5.0 DESIGN FEATURES

CALVERT CLIFFS - UNIT 1

Amendment No. 169

FIGURE 5.1-1

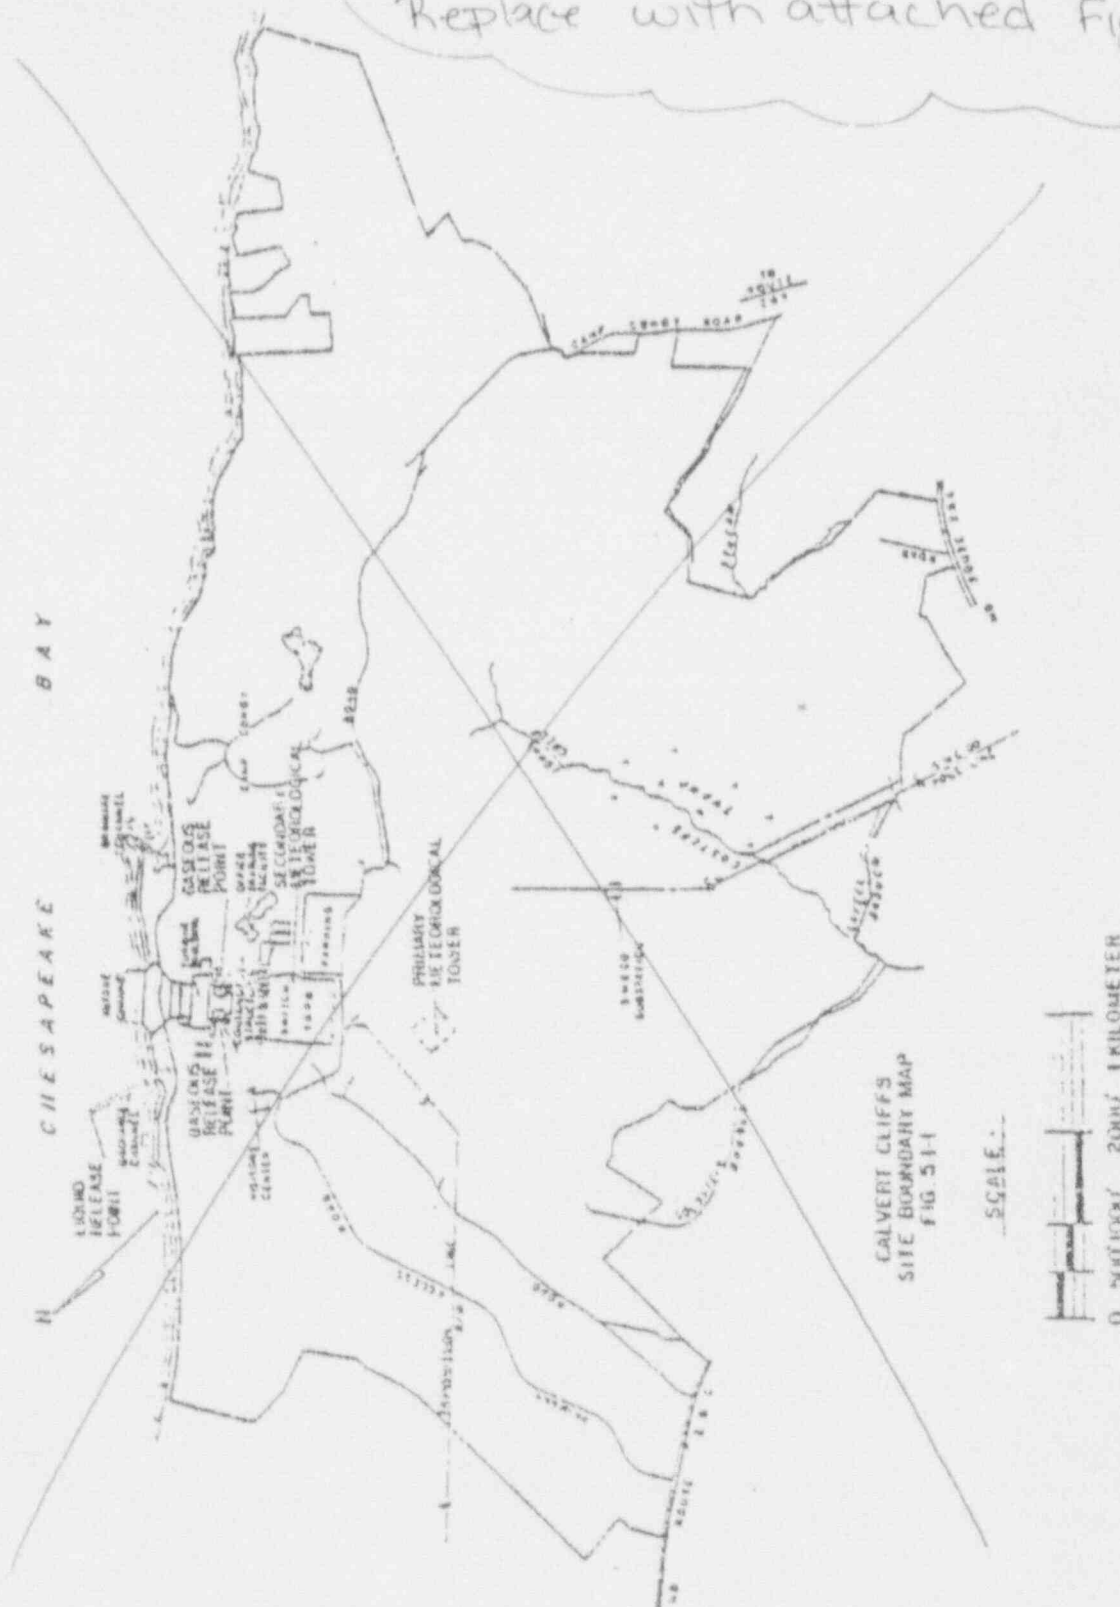
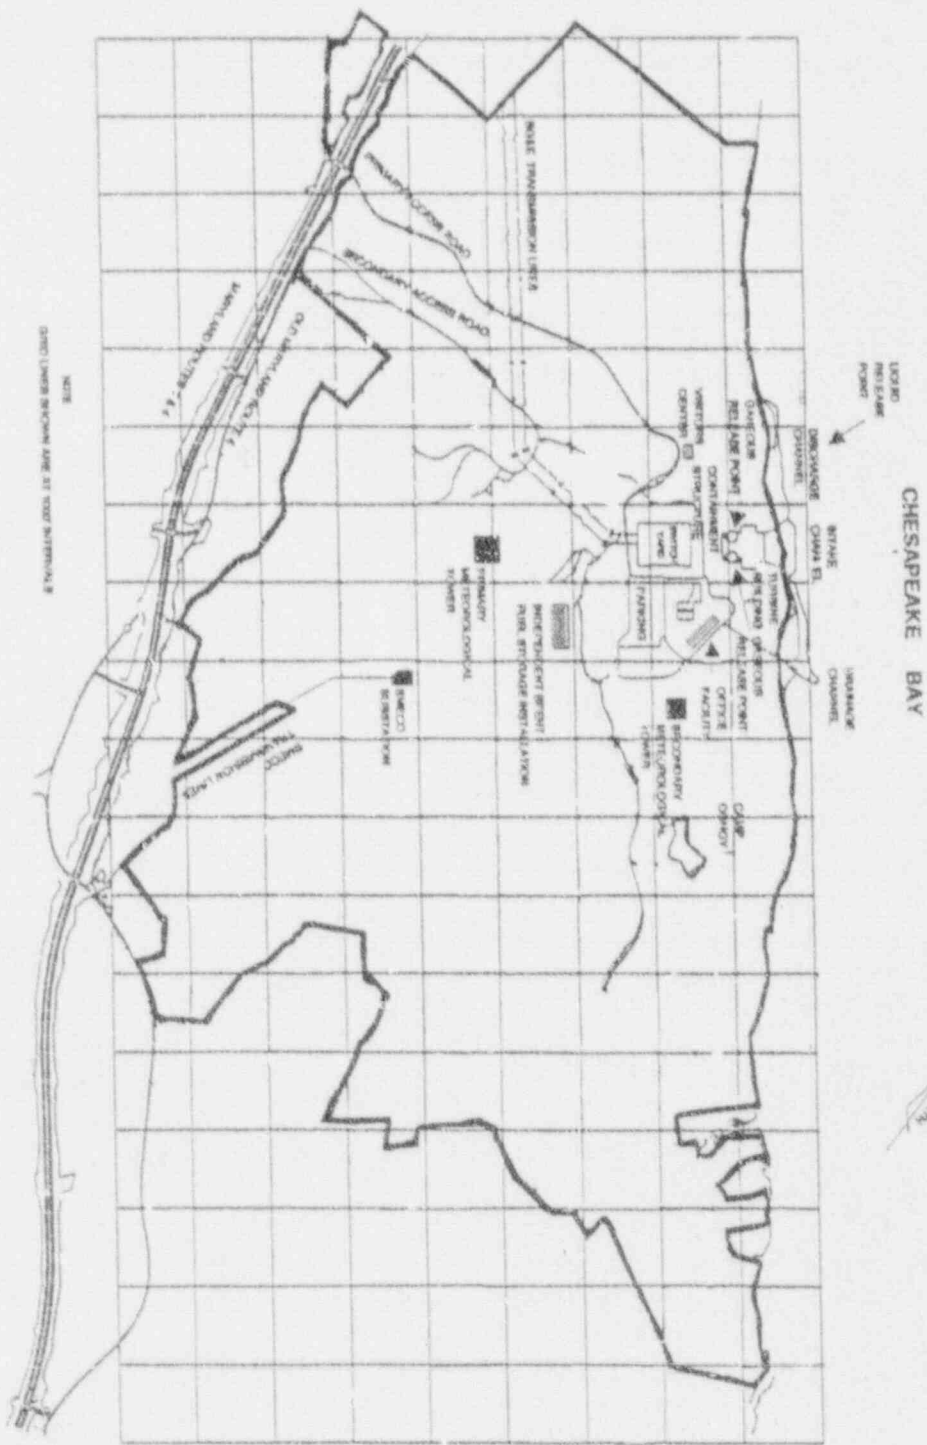
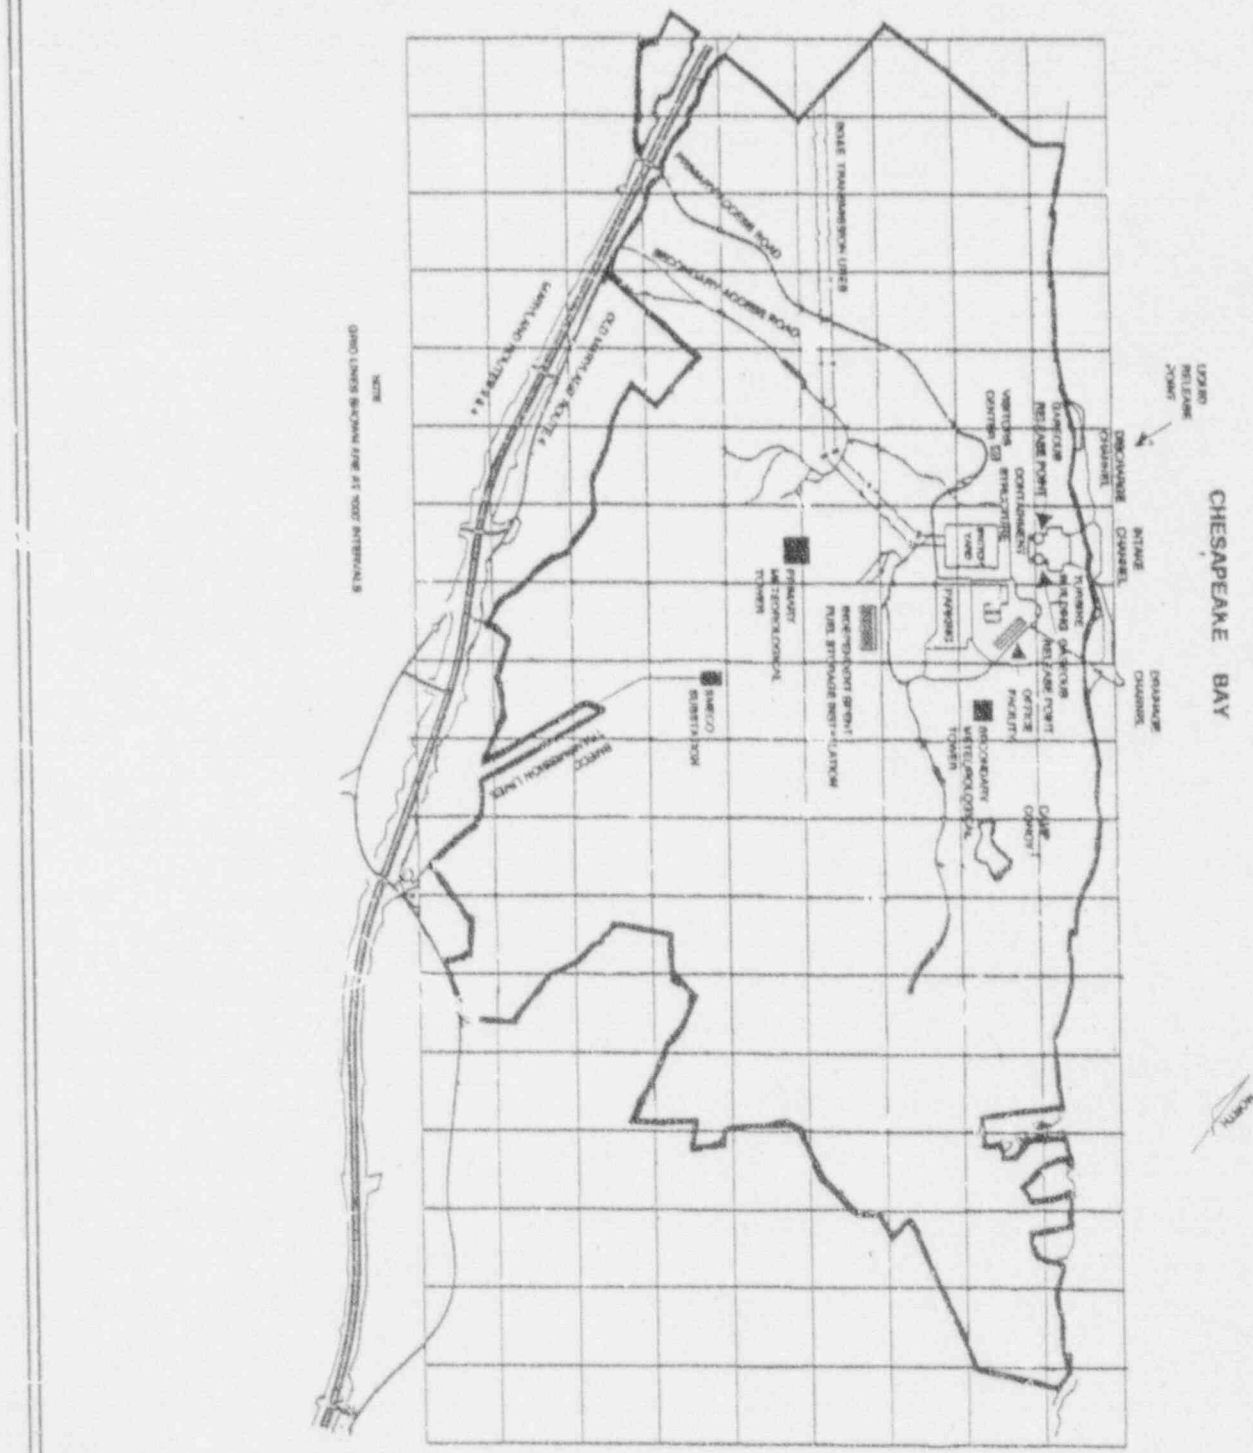
Replace with attached Figure

FIGURE 5.1-2
LOW POPULATION ZONE

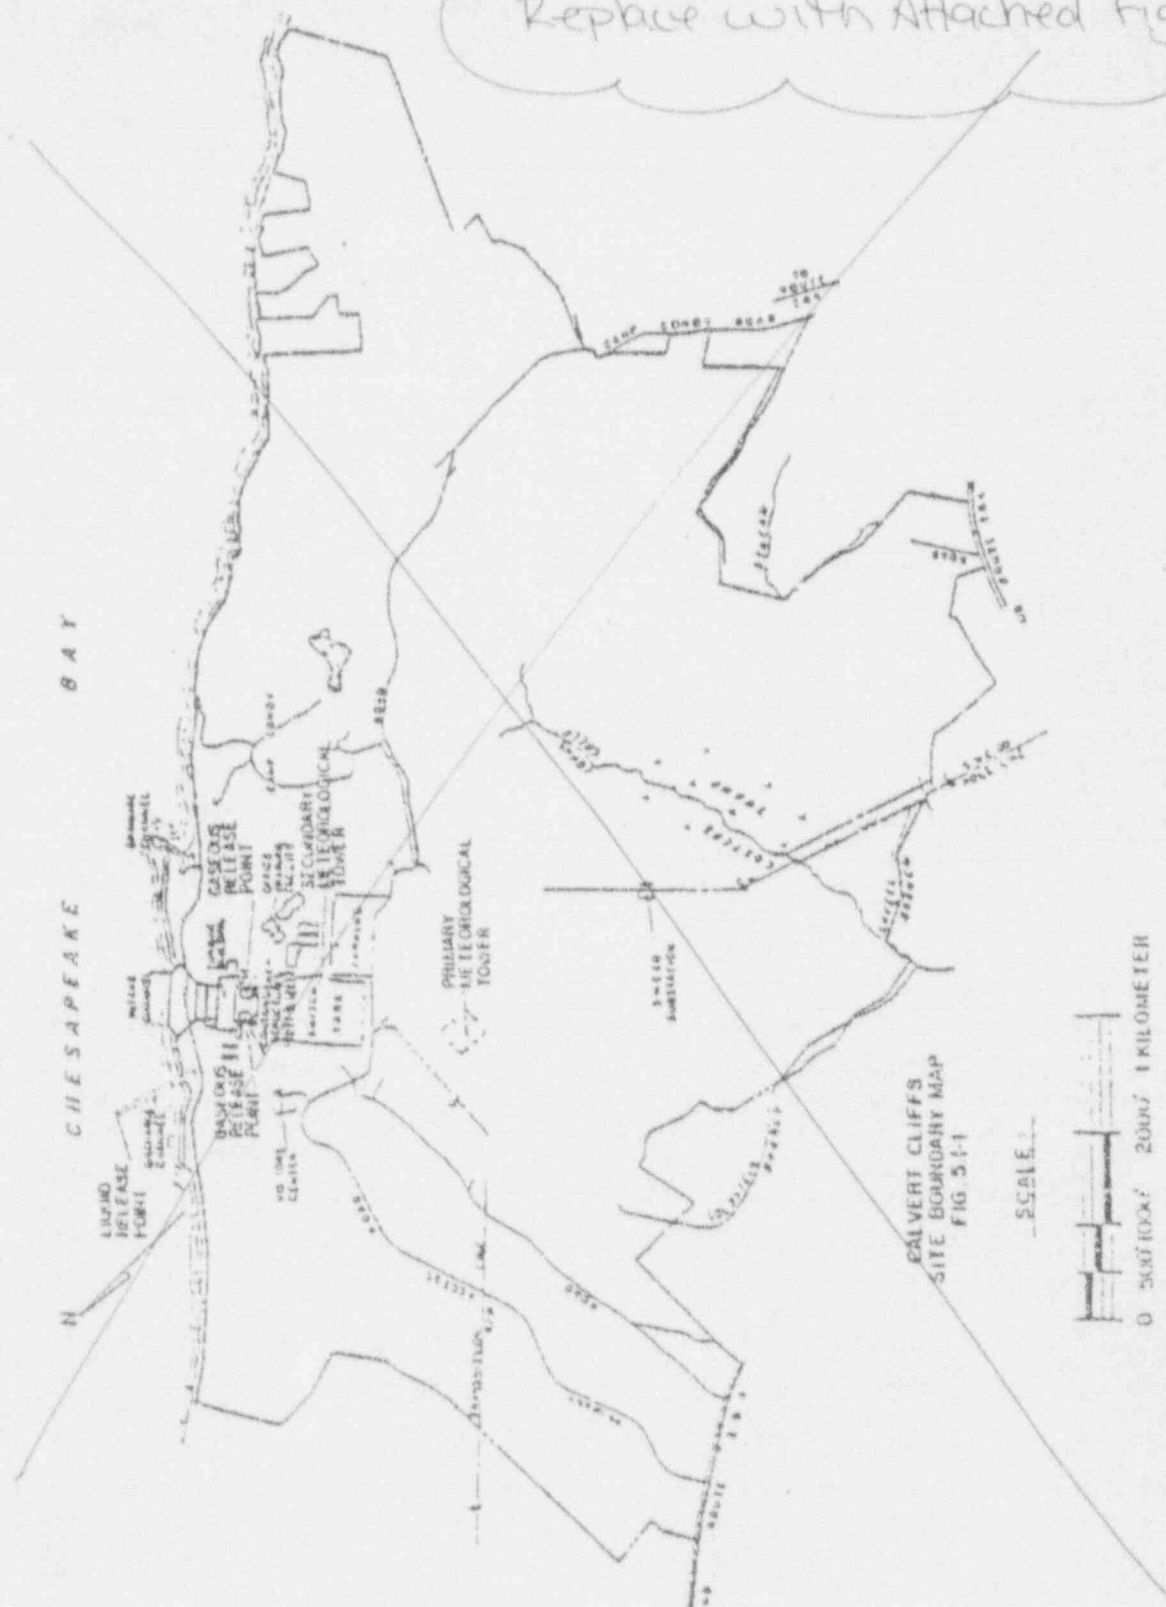
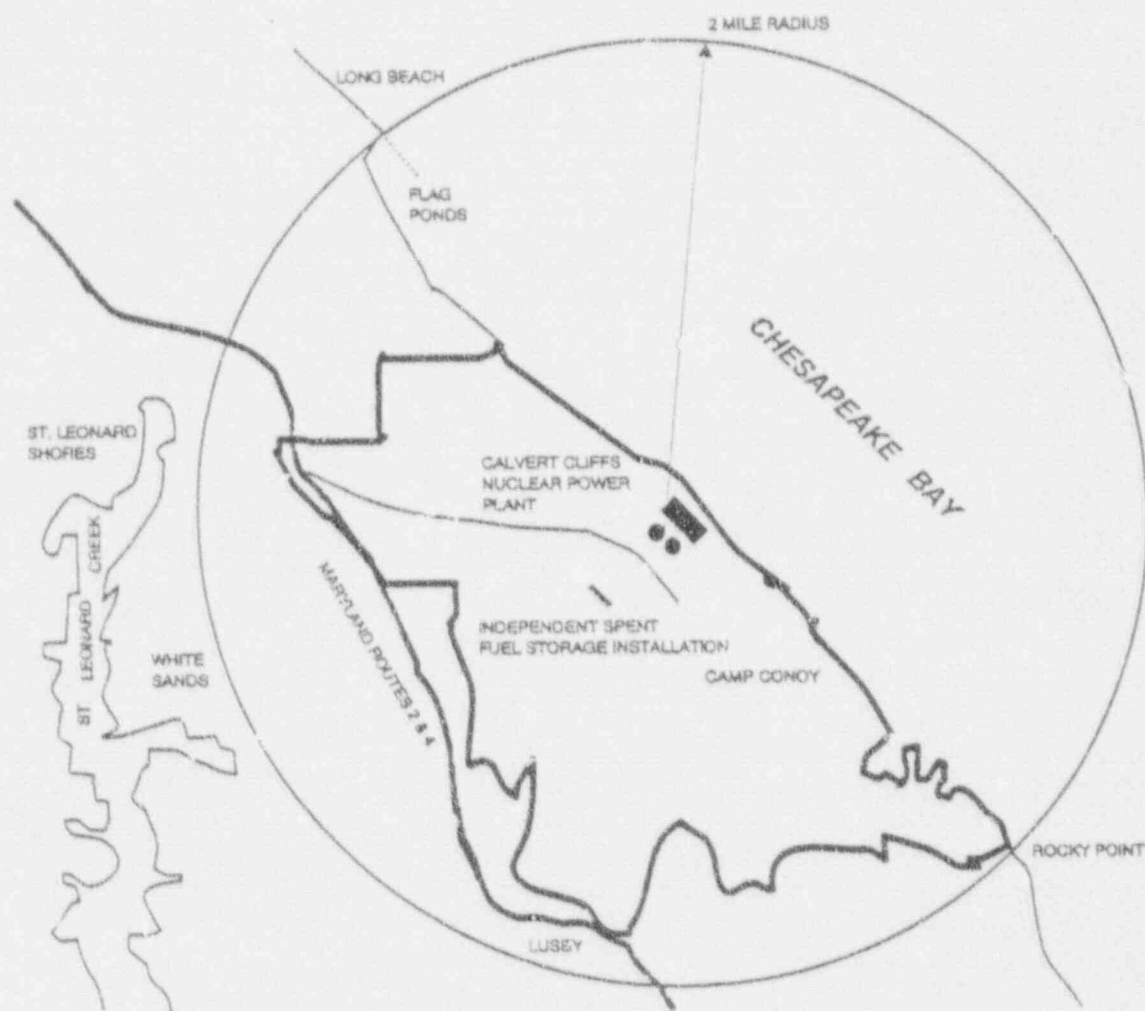
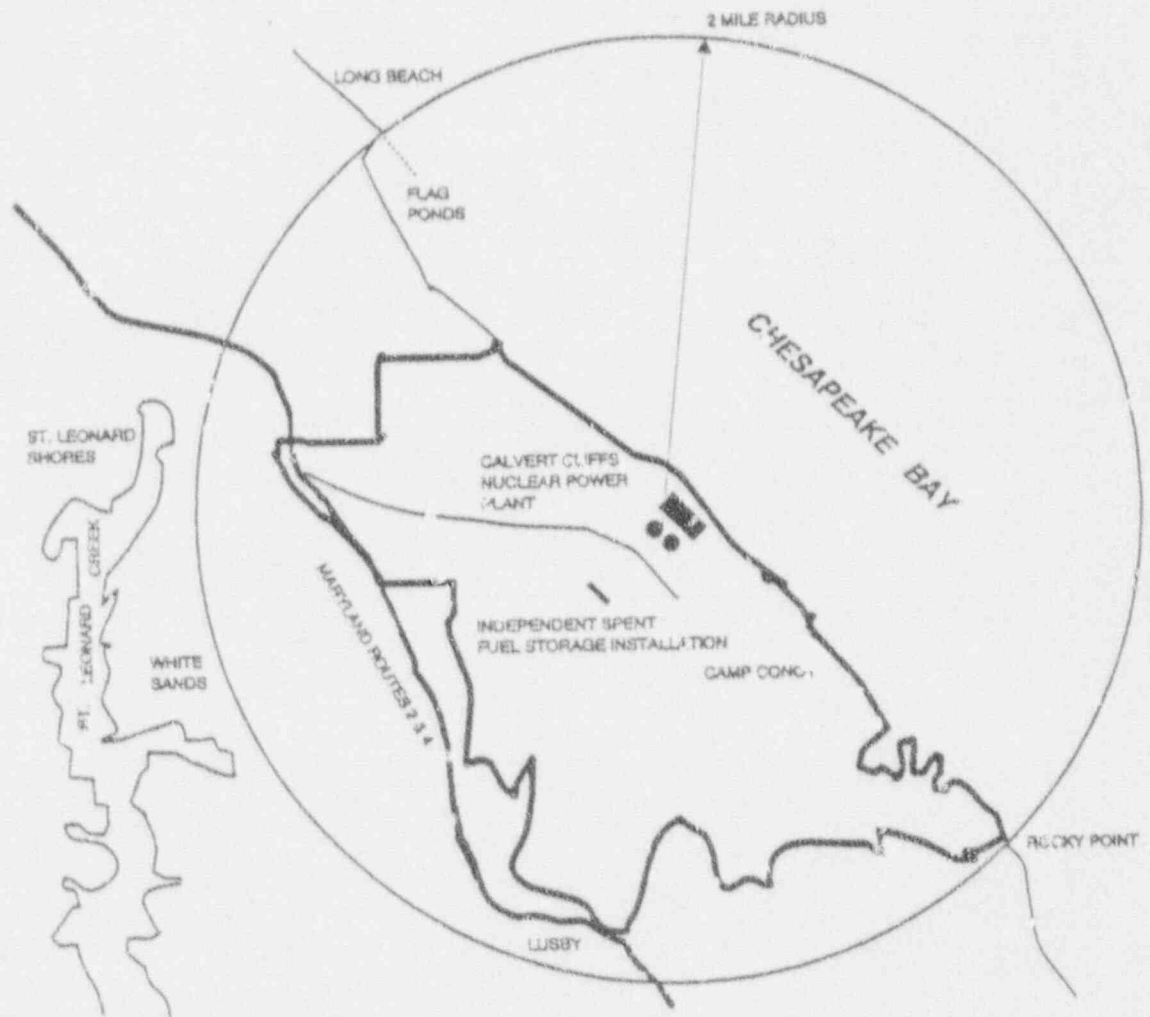
Replace with Attached Figure
